ADVENTHEALTH PARKER EXPANSION

DRAWING TITLE: WATER AND SANITARY COVER SHEET

DRAWING NUMBER:
C511

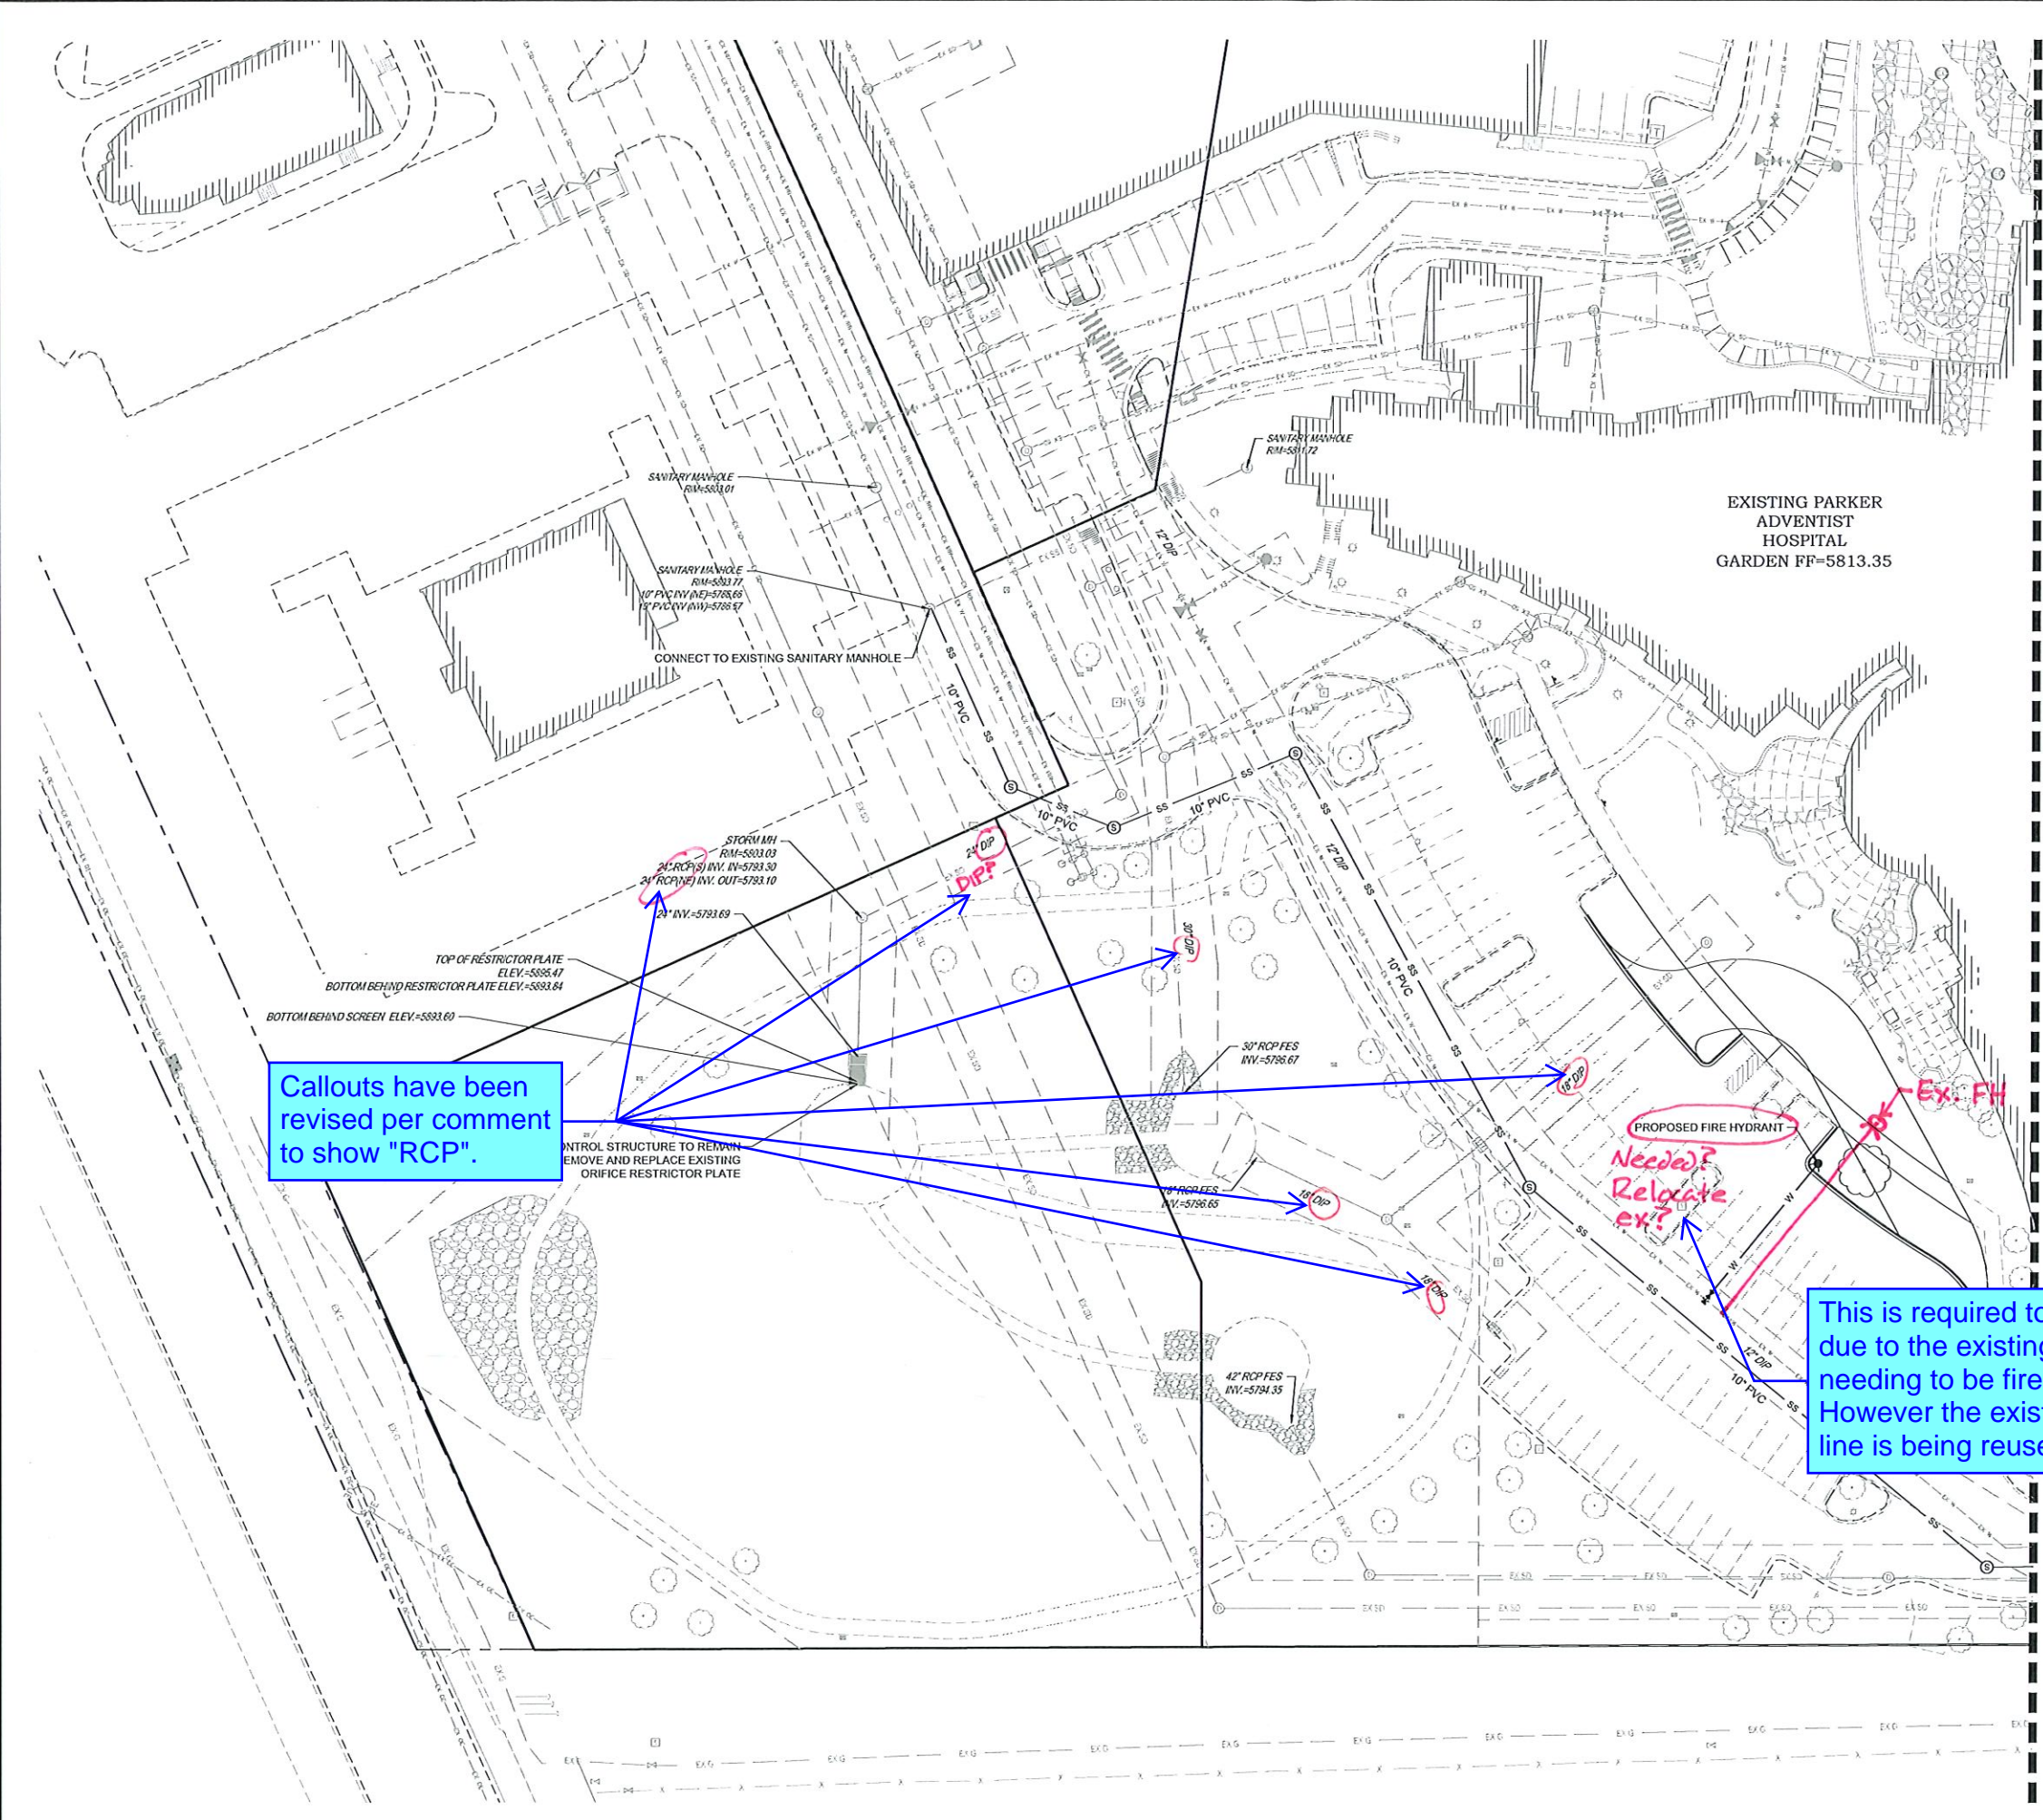
is 4" still sufficient?

Provide Plan & Profile for proposed water. ✓
 Callout all fittings, valves, pipe size & material, etc.
 Provide a Demo plan.
 Show Proposed Easements

Callouts have been revised per comment to show "RCP".

This is required to be relocated due to the existing location needing to be fire truck accessible. However the existing hydrant fire line is being reused

Gate valves added per comments.

Revised to show RCP.

Water plan and profile included.

Grease interceptor connection has been added to the plan.

Callouts have been added per comment.

Gate valves added per comments.

Demo plan provided.

All easements are shown on utility plan per comment.

Callout has been revised per comment to show "RCP".

DRAWING NUMBER:
C531

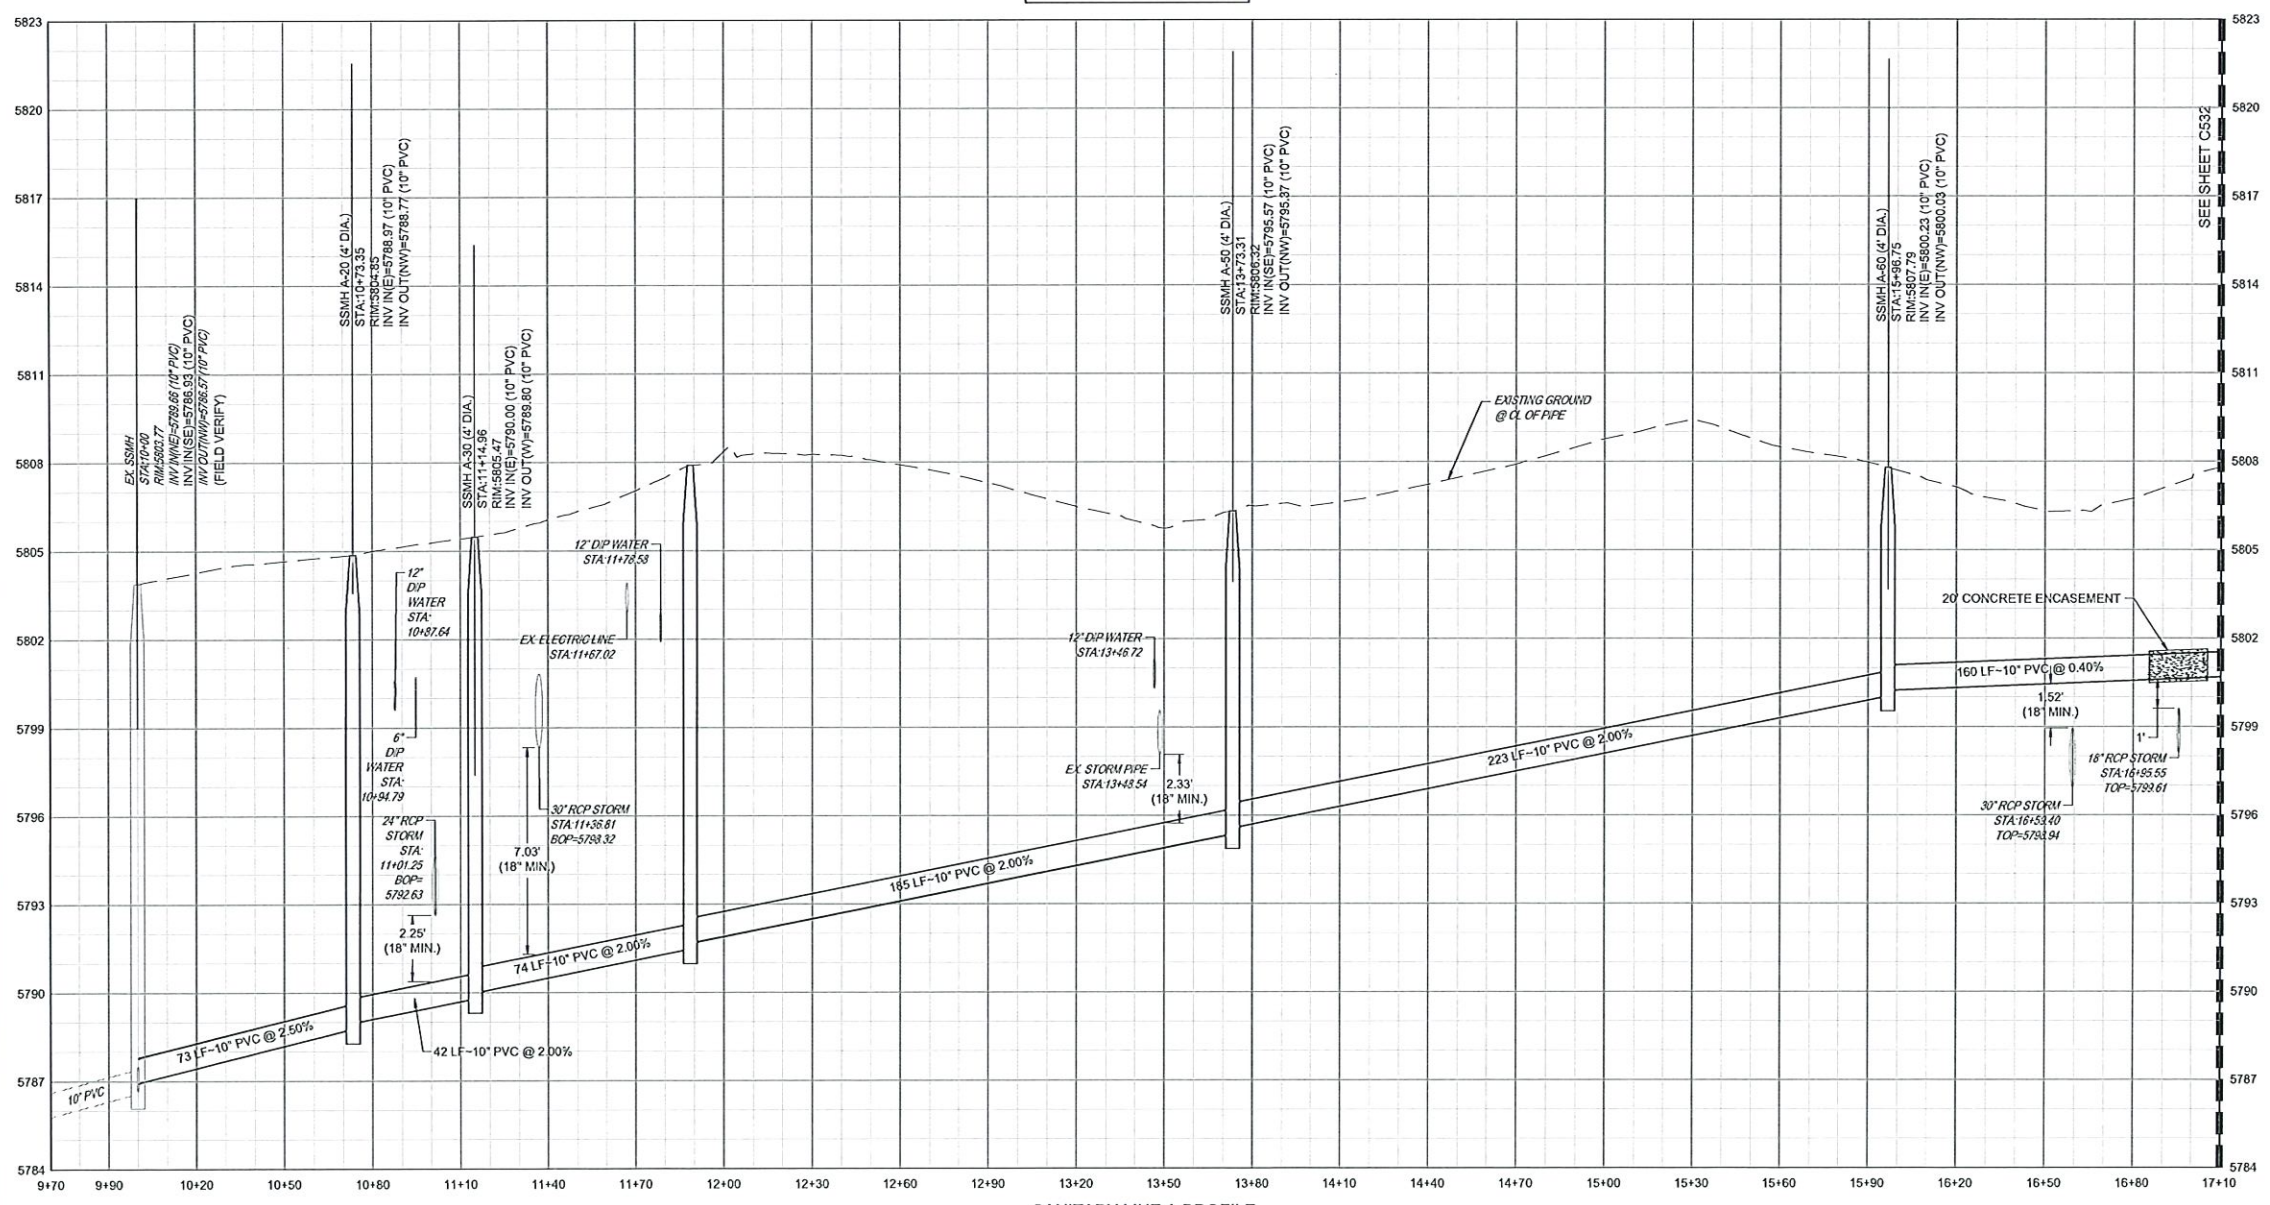
Mapping Shows Ex SS here. Confirm.

If so, Remove.

Dimensions added per comment. (Typ.)

We have confirmed in the field that no sanitary exists in this area.
